ADDENDUM NO. 1

May 22, 2024

Community Center Perimeter Fence Project No. 24-CC-0001

SHEET DESCRIPTION: PROPOSED FENCELINE

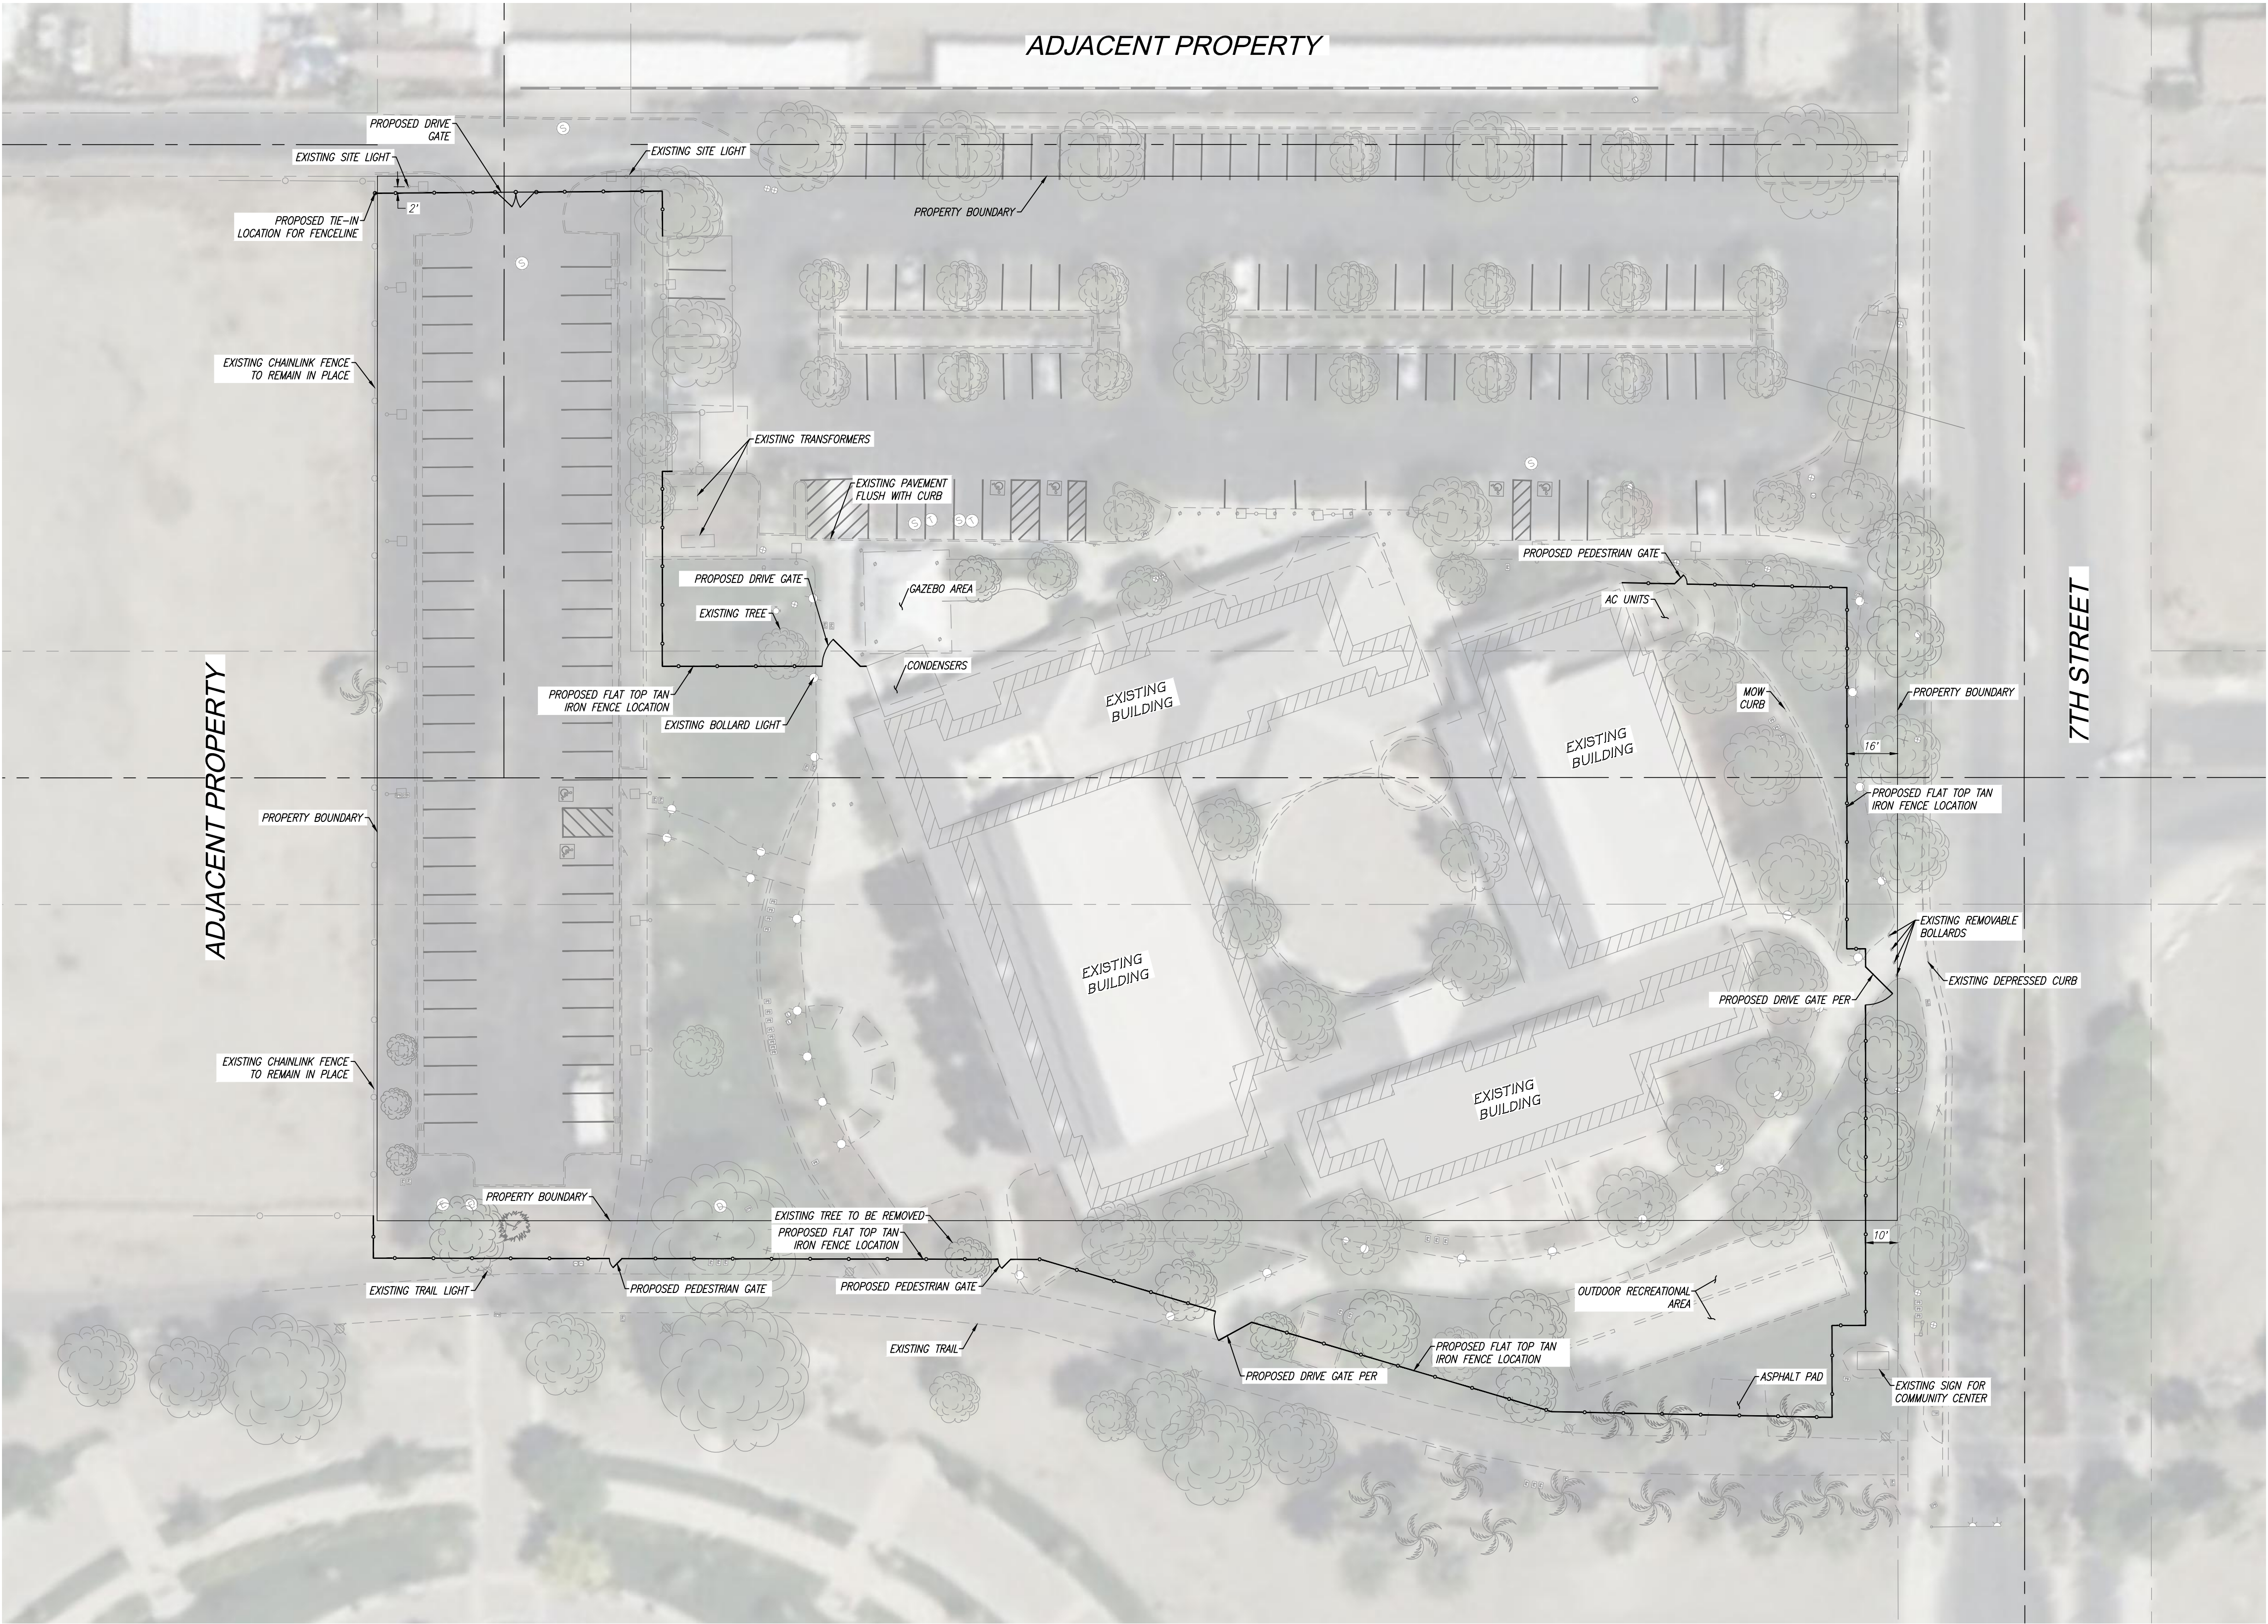
1. **Question:** The Plans call for 6' chain link fence and gates; bid items and the last page of the project manual call for flat top tan iron fence and gates. If is to be iron, can you please provide more detail on post, rail and picket size?

Response: Please see Exhibit A for updated plans. This can also be found using the following link:

- 1-1/2 x 1-1/2 rails, 3/4 pickets, 2-1/2 x 2-1/2 11gauge posts
- Posts are to be set 2 feet down in concrete
